15.7 Radioactive Release from Subsystems and Components

The information in this section of the reference ABWR DCD, including all subsections, figures and tables, is incorporated by reference with the following departure and supplements.

STD DEP 11.3-1 (Figure 15.7-2)

Figure 15.7-2 Offgas System (See Subsection 11.3)

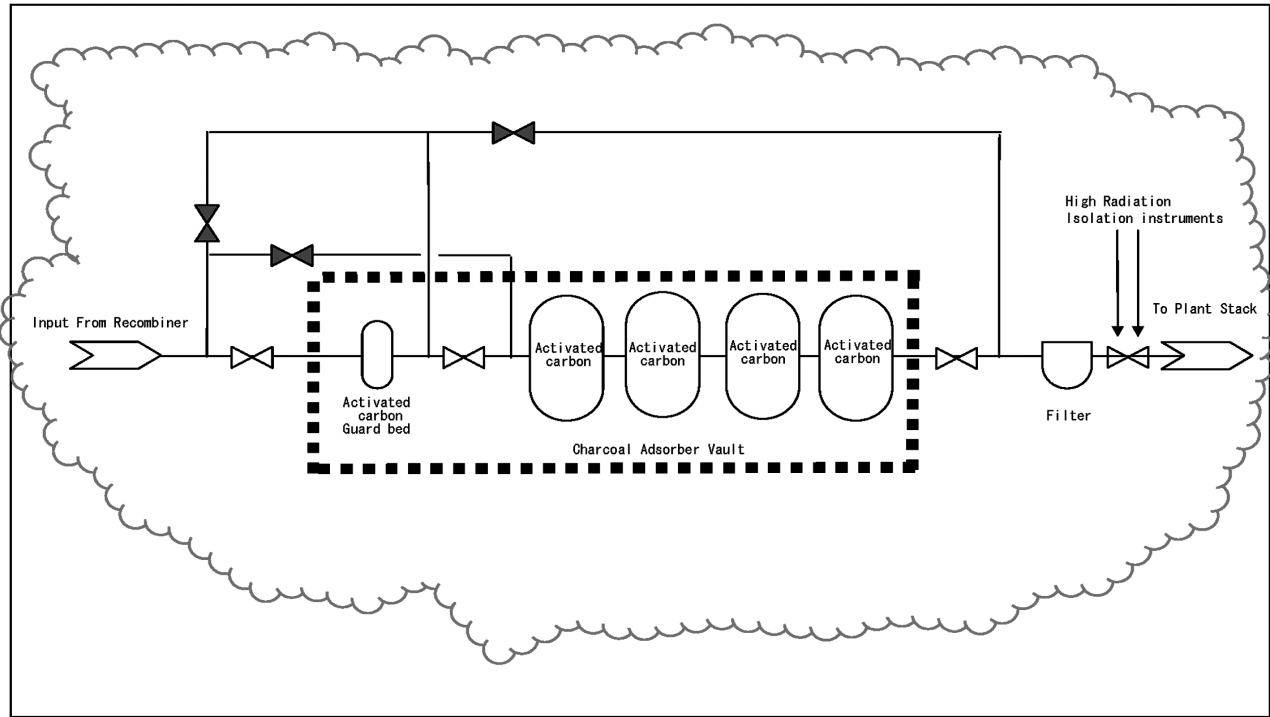
STD DEP 11.3-1

To evaluate the potential radiological consequences of an inadvertent bypass of the charcoal beds, it was assumed that operator error or computer error has led to the bypass of the ~~eight~~four follow-on beds in addition to the failure of the automated air operated downstream isolation valve. It is also assumed that during this period, the plant is running at and continues to run at the maximum permissible offgas rate of 14.8 GBq/s (based upon the assumption of 0.0037 GBq/s/MWt as stipulated in Standard Review Plan 11.3) evaluated to a decay time of 30 minutes from the vessel exit nozzle. Even with the failure of the downstream isolation valve, it is not anticipated or assumed that the isolation instrumentation would fail but would instead

- (1) Flow is through a single 4,721 kg charcoal tank with an evaluated hold up time given by NUREG-0016, equation 1.5.1.6 using K_d 's for Kr and Xe from NUREG-0016.
- (2) ~~An isolation valve prevents flow through the~~ ~~There is no motive force to remove any significant inventory from the eight~~ follow-on charcoal tanks while in bypass and therefore no activity from these tanks is included in the final release calculations.
